North-South Interconnector Project Independent Experts Review 2021

In 2021 a new independent International Expert Commission (IEC2021) has been set up by the Irish Department of the Environment, Climate & Communications (DECC) to undertake a review of the North-South Interconnector (NSIC) project with the following purposes:

Figure 2. Comparison of losses for VSC-HVDC UGC, HVAC UGC, HVAC OHL

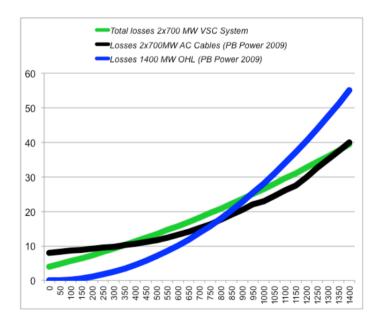
This can be noted by representing in a diagram the variation of power losses (in MW, vertical axis) with the power transfer (in MW, horizontal axis) of the three technological options, such as HVAC OHL, HVAC UGC, VSC-HVDC UGC, for a 1400 MW rating (see Figure 2).

The IEC2021 fully agrees on the above statements by the IEC2012. The IEC2021 has however to stress that the expected OHL costs can nowadays be increased also significantly with new towers design having a less intrusive visual impact: in fact, this would come with higher (up to double) investment costs for such HVAC OHLs with respect to standard HVAC OHL solutions.
